Enclosed are your NRC License Number 15-24485-01, issued to MEDIQ Mobile Services, and Amendment No. 21 which terminates NRC License Number 24-18094-01 issued to Mobile Medical Services.

Please note that the new license does not include your facility on Main Street in Lexington, Missouri. In order for us to consider this request further, it will be necessary for you to submit the following information:

Re: License # 24-18094-01

MEDIA MOBILE SERVICE  
924 MAIN  
LEXINGTON, MO

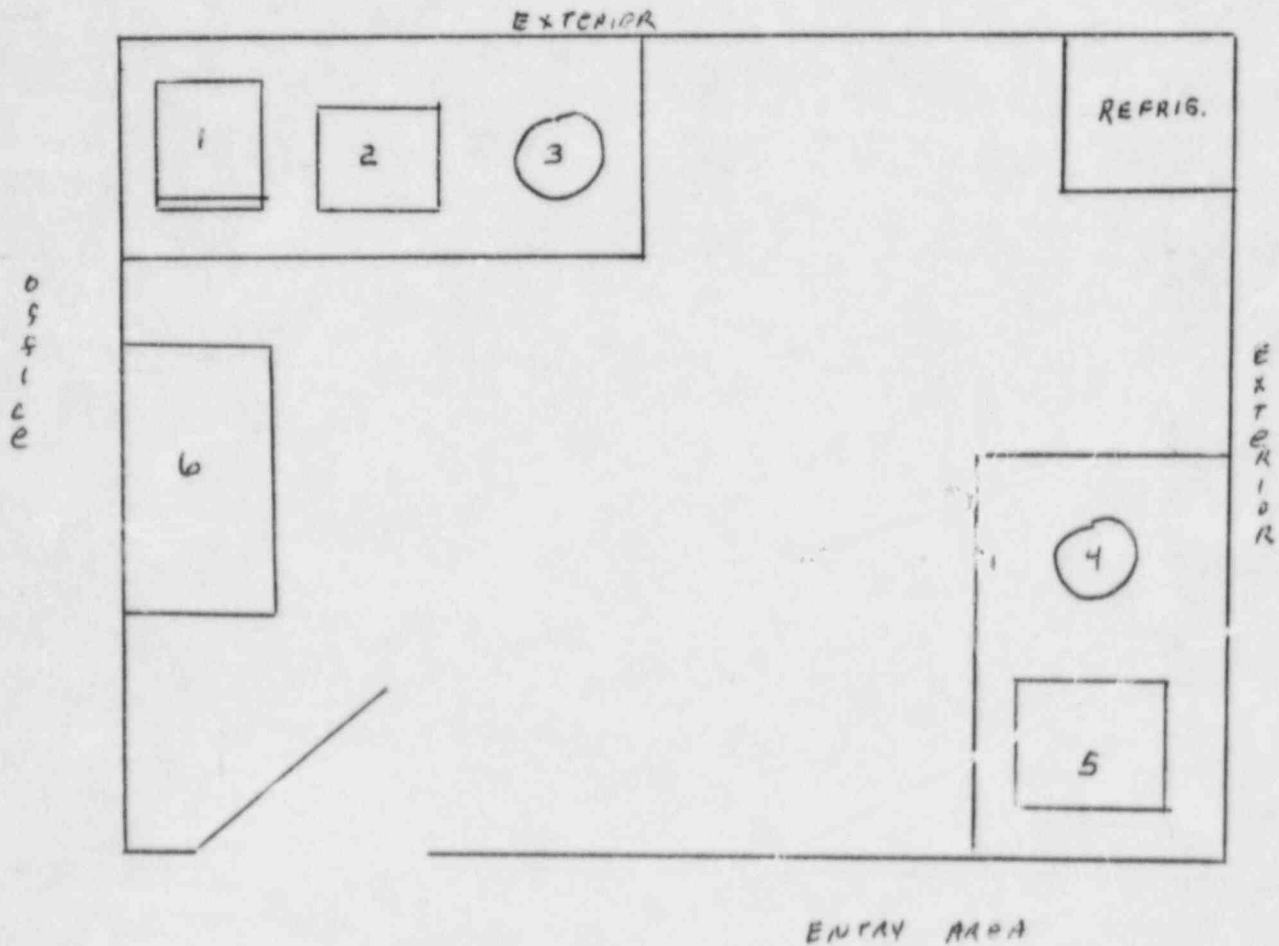
- a. A clearer description of your new facility including the type of building it is housed in. Also, if the adjacent office does not belong to MEDIQ, will you have access to the office for making radiation measurements to determine compliance with Section 20.105 of 10 CFR 20?
- b. A description of the shielding material to be used for your generator and waste storage area. (If the shielding is the same as that specified in the Mobile Medical Services license application dated June 24, 1983, please so state.)
- c. The method to be used for controlling access to the lab and for insuring that licensed materials are secured from unauthorized use or removal.
